From: Schulten, Carl
Sent: Monday, April 11, 2011 11:43 AM
To: Poole, Justin
Subject: RE: Watts Bar 2 TS
Attachments: WNB2 TS Validate Developmental A & B Binder.pdf; WNB2 Bases Validate Developmental A & B Binder.pdf

Per your request, attached are pdf files of the WBN-2 Specs and Bases with my comments embedded.

Can you send me the file with your marked up comments. We would like to send them to TVA so we can have a meeting in the near future to discuss and resolve. Thanks.

Figure B 3.2.1-1 (page 1 of 1)
K(Z) - Normalized $F_Q(Z)$ as a Function of Core Height

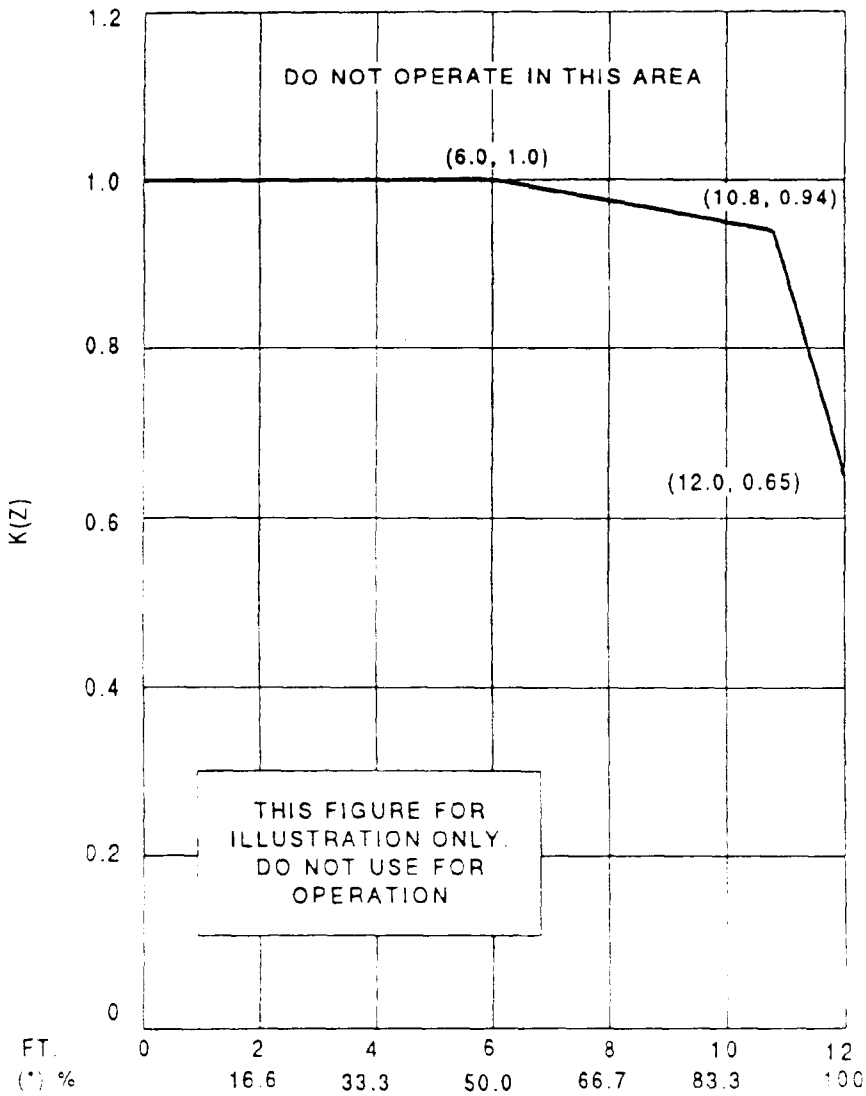
Revision 99 to WBN1 TS Bases per Westinghouse Technical Bulletin 08-04. Technical Branch Confirmatory

Open Pending Receipt of Information

Figure B 3.2.3-1

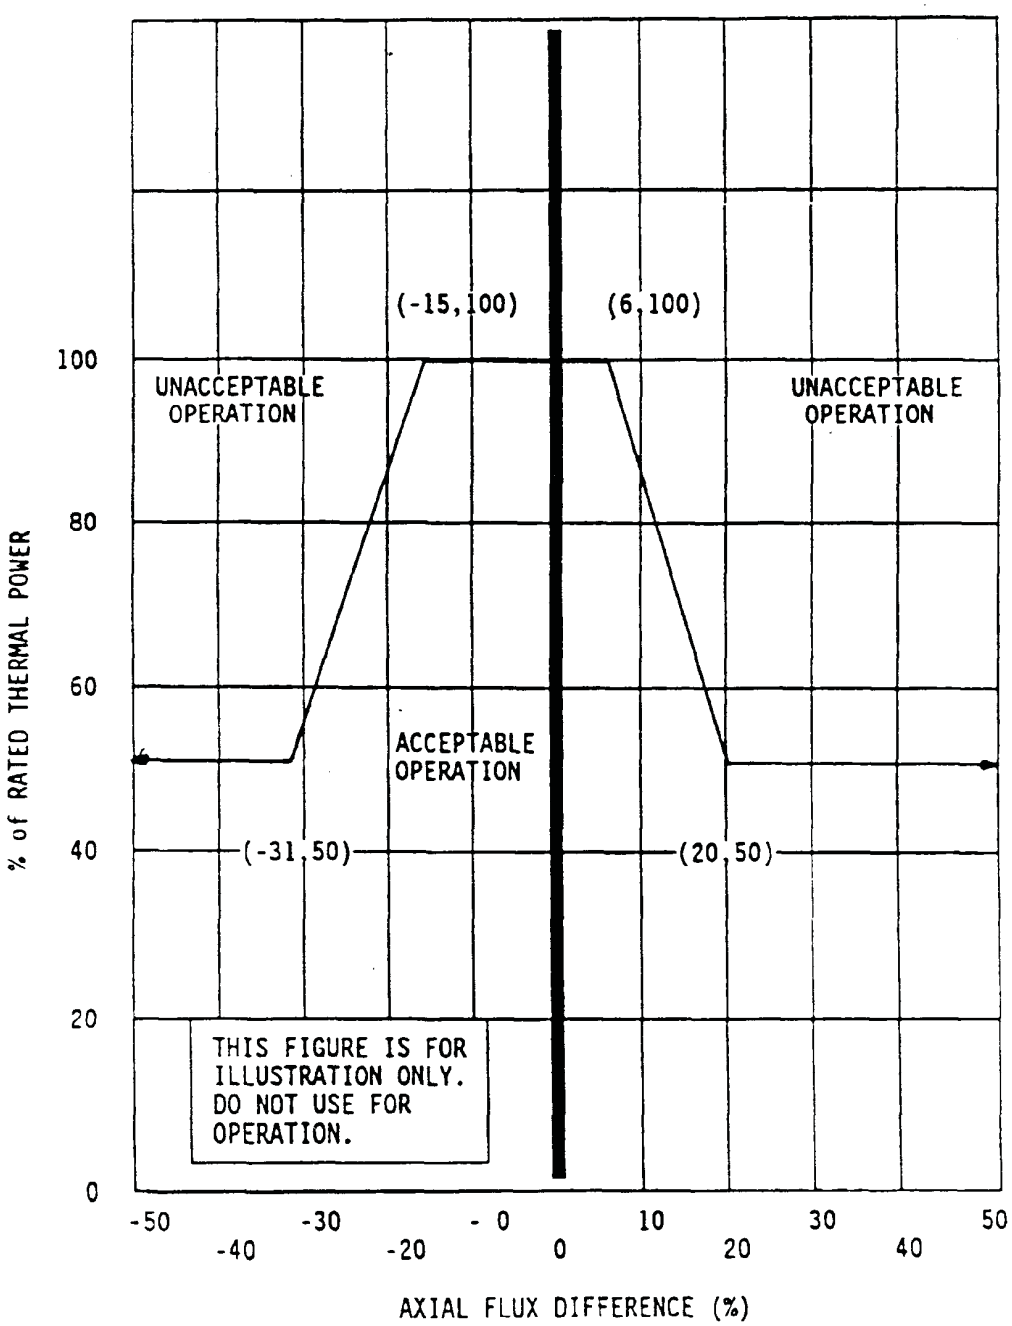
Confirmatory approval needed from SCPB
